HIGHWAYS REPRESENTATION

NO OBJECTION SUBJECT TO CONDITIONS

Planning Reference:	25/01315/FUL
Location:	Land Adjacent 3 Brickfield Cottages, East Cowes Road, East Cowes, PO32 6NH
Proposal:	Proposed detached dwelling and garage
Road Status:	Unclassified publicly maintainable highway
Date of Site Visit:	12 September 2025
Date of Report:	17 September 2025
Planning Case Officer:	Hayley Byrne

Plan no. PL01-003 rev D

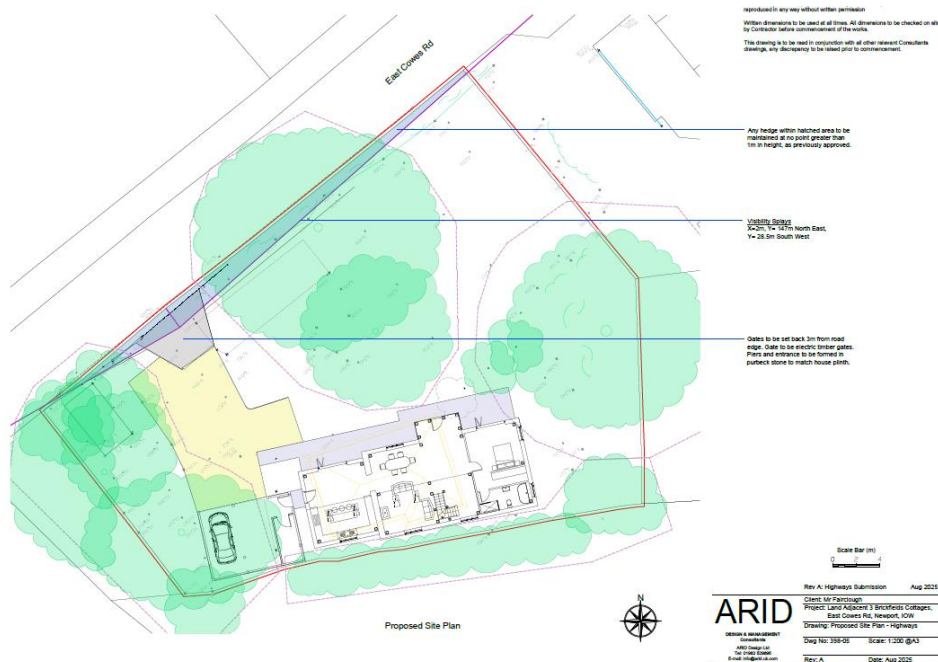
However, the history of the site is a material consideration and it has previously been accepted by this Office that betterment to visibility would outweigh any potential harm caused by non-compliance with current standards. The degree of improvement is shown below on approved plan no. PL01-003 rev D:

As previously agreed, this Office has accepted that speeds would be more reflective of a 50mph environment due to the alignment of the carriageway and Y distances of 147m were accepted. A 5m set back for gates was also accepted. In accordance with design standards (Design Manual for Roads and Bridges) any new or existing vehicle access forming a junction with this part of the highway network at which the proposed development would have a material impact (i.e. increase flows by 10% or more) should provide minimum junction/access visibility splay distance of 147m.

It has previously been accepted by this Office that visibility splays of 27.5m to the north-east and 147.0m to the south-west measured from an X point 2.0m back from the carriageway edge would be acceptable.

Plan no. 398-05 rev A

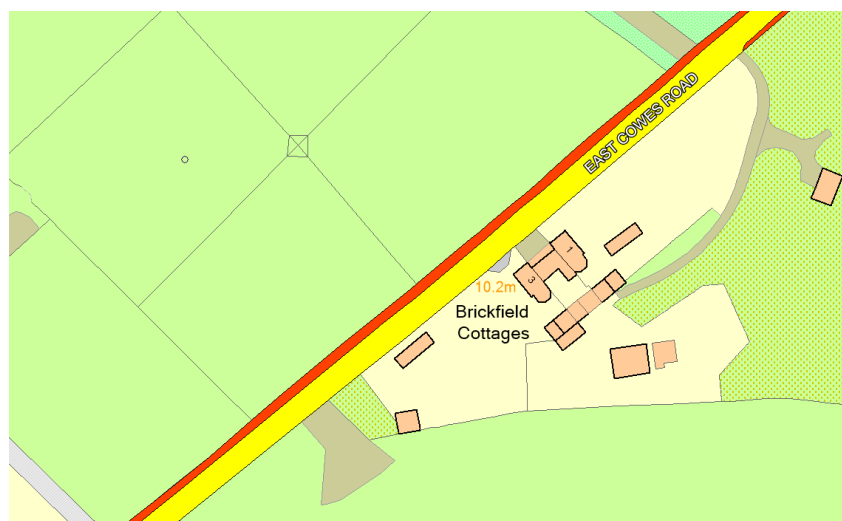
The visibility sight line distance (Y) is measured from the X point at a height of 1.05m, central to the access and to the Y point on the near kerb line (kerb on development side) between

the heights of 0.6m and 2.0m above the carriageway The splays must be achievable within land under your control or/and the limit of the adopted highway.

The visibility sight lines have been shown to be achievable as shown on submitted plan no. 398-05 rev A.

The development hereby approved shall not commence until sight lines have been provided in accordance with the visibility splays shown on the approved plan 398-05 rev A. Nothing that may cause an obstruction to visibility when taken at a height of 1.0m above the adjacent carriageway / public highway shall at any time be placed or be permitted to remain within the visibility splays.

The dwelling hereby approved shall not be brought into use until the means of vehicular access thereto has been constructed and drained in accordance with details to be submitted and approved in writing by the Local Planning Authority based on the layout as detailed on drawing number 398-05 rev A.

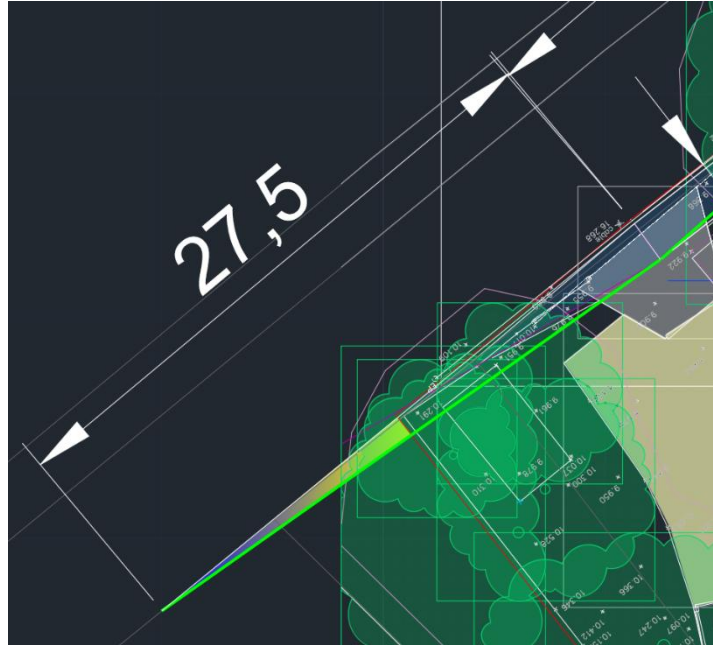
It should be noted that there is no recorded highway verge on the southern side of East Cowes Road:

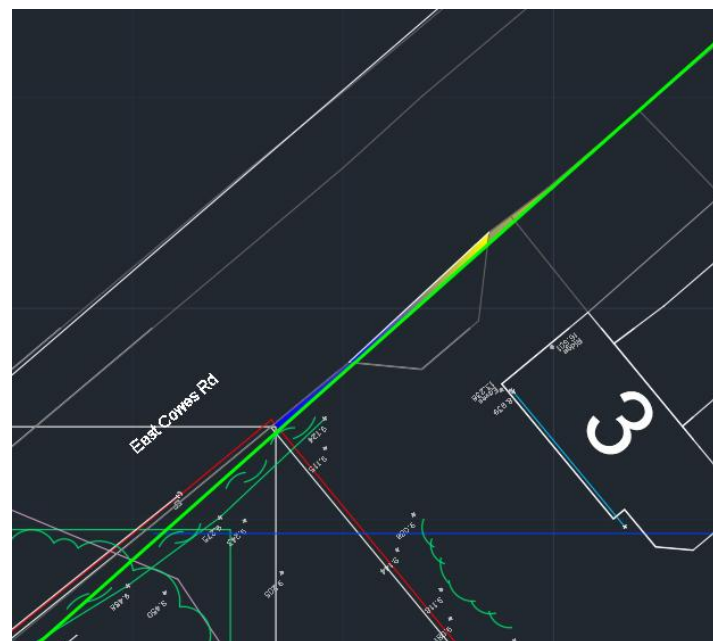
Both splays will fall outside the extents of publicly maintainable highway and the land under the control of the Applicant:

Extent of visibility splay on third party land to the west of the access

Extent of visibility splay on third party land to the east of the access

I can confirm that this proposal can be made in compliance with this standard subject to a pre-commencement condition being attached.
